INTERNATIONAL
URANIUM (USA)
CORPORATION

Responses to NRC Letter Dated August 19, 1997 and December 5, 1997, Regarding NRC
Acceptance Review of the Reclamation Plan for the White Mesa Uranium Mill

Source Material License SUA-1358
Docket No. 40-8681

**Response to Nuclear Regulatory Commission / White Mesa Mill Reclamation Plan
Comments Dated August 19, 1997
Source Material License SUA-1358**

ATTACHMENT 3

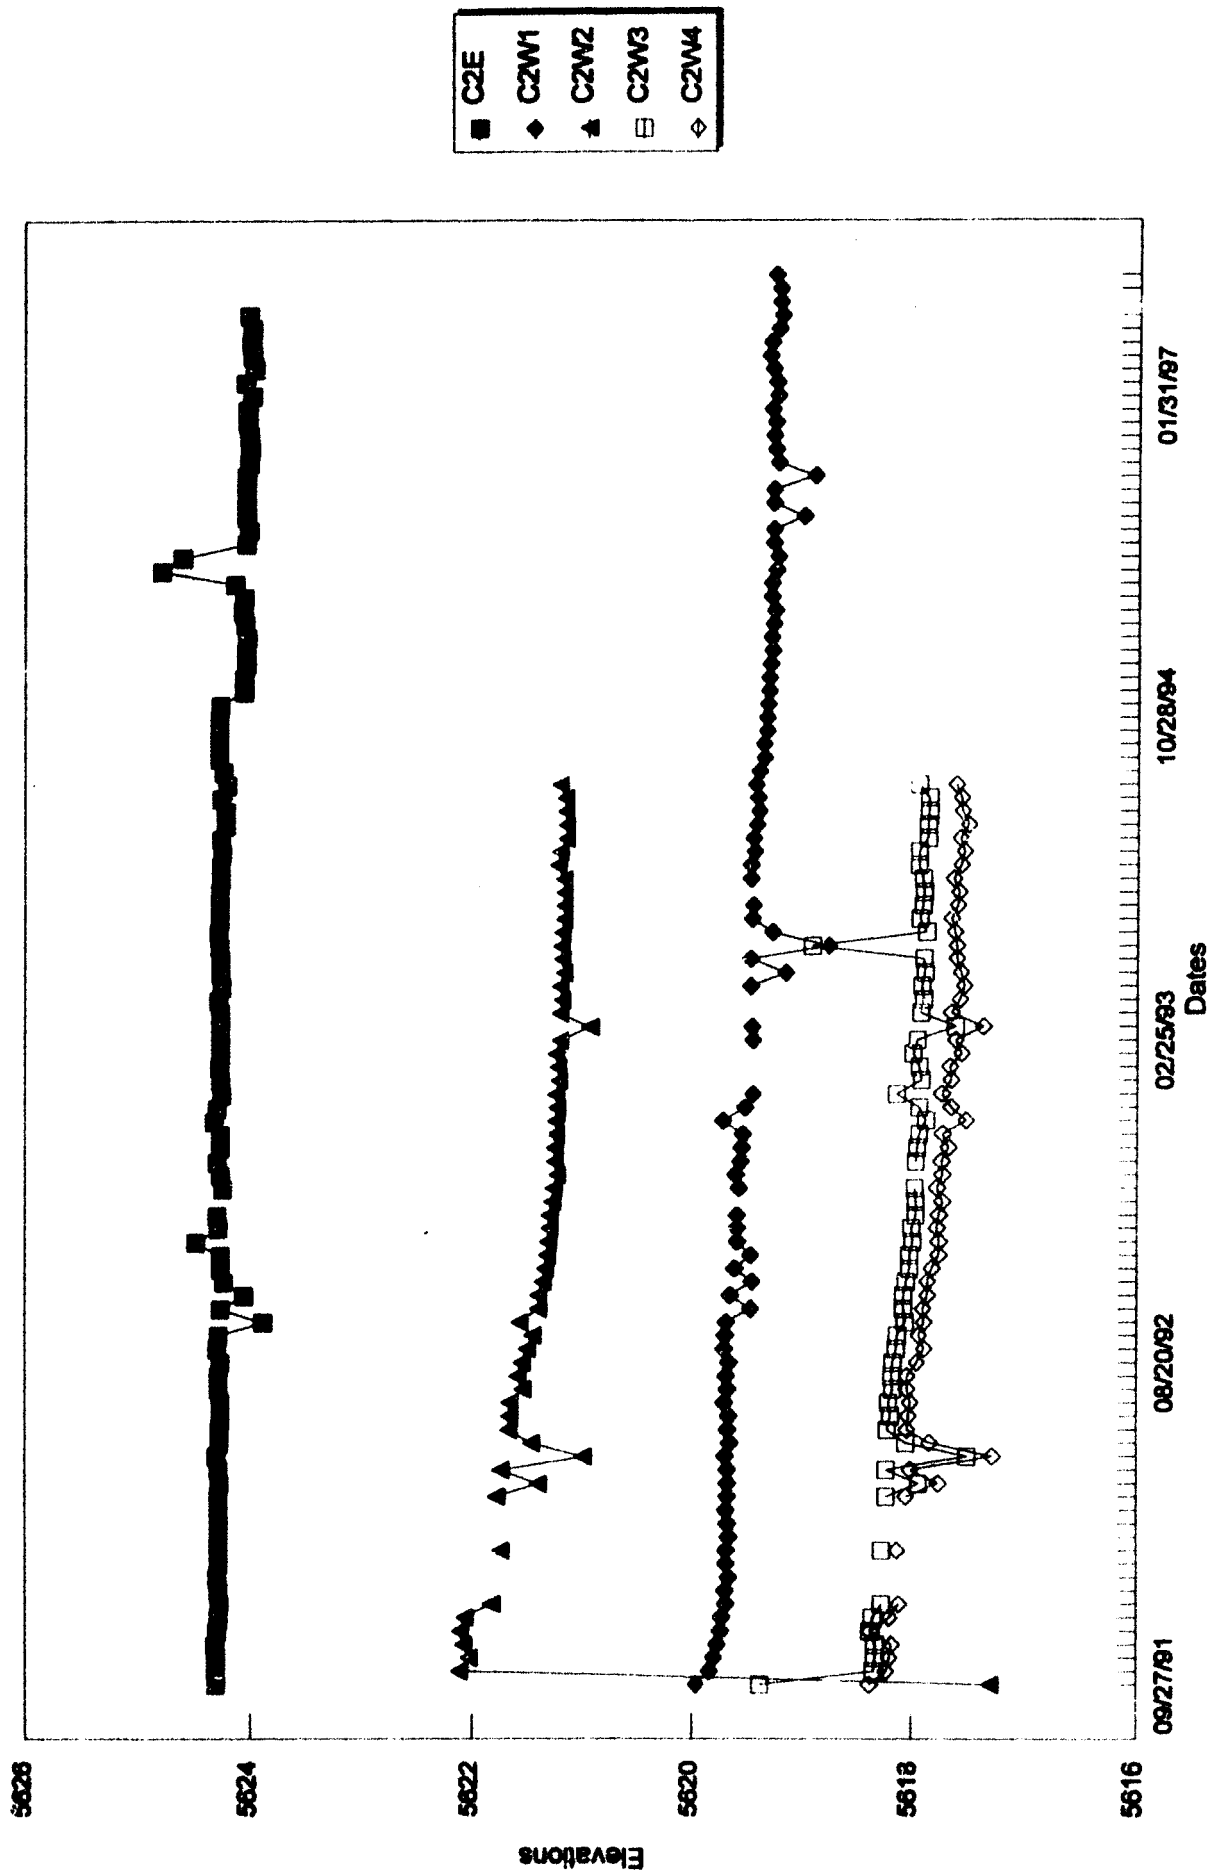
(2) *An analysis of the total and differential settlements of the tailings surface and the effects of such settlements on soil cover integrity.*

Analysis of the total and differential settlement of the tailings surface was performed using the survey data compiled for the five settlement monuments installed within Cell 2. These monuments were installed on the surface of the tailings, between August 1989 and November 1992, prior to the placement of approximately three to four feet of random fill material. Survey results of each monument were plotted as time vs. settlement graphs and are presented in Attachment 2 of this response.

Review of the survey data and graphs shows that primary consolidation of the tailings has occurred, and the settlement rate has been very slow with minor total values. The maximum total settlement recorded is 0.97 feet, and the differential settlement is on the order of 0.50 feet. Approximately 81 percent of the total measured settlement occurred within the initial three years. Additionally, recent survey data indicates that the settlement has virtually stopped. From September 1995 to September 1997 the settlement averaged less than 0.03 feet per year, which is within the expectable survey error of 0.05 feet. This indicates that the settlement since 1995 is negligible.

Placement of the final reclamation cover will induce additional settlement. However, since primary consolidation of the tailings has occurred, under current loading conditions, additional settlement is expected to be less than the total settlement values to date. This minor amount of additional settlement, due to the added surcharge of the cap, will not effect the integrity of the six foot thick final reclamation cover.

FIGURE 1

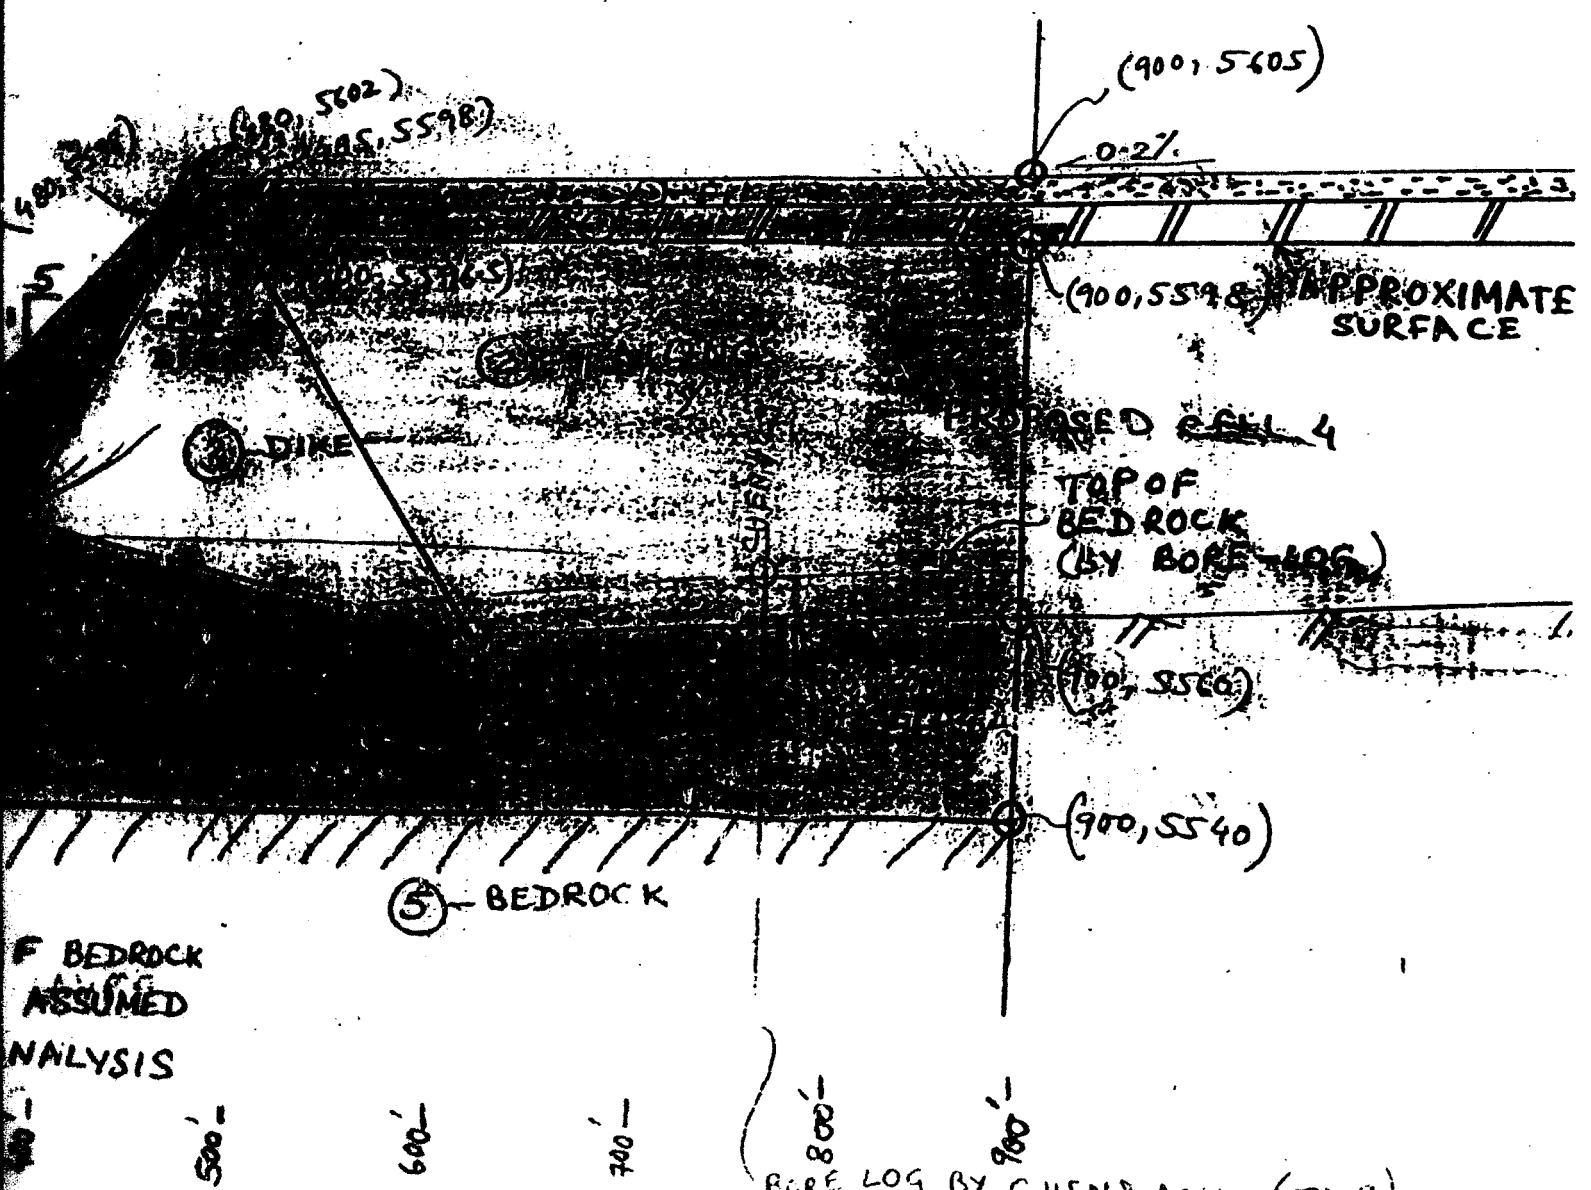
- (11) A replacement of seven pages of illegible data. These pages are in appendix A of Appendix D [Tailings Cover Design White Mesa Mill, October 1996 (pages marked p. 12 through p. 17)] and in appendix G of Appendix D [Tailings Cover Design White Mesa Mill, October 1996 (figure showing cross-section along Cell 4 dike)].**

The seven replacement pages are included in Attachment 3 of this response.
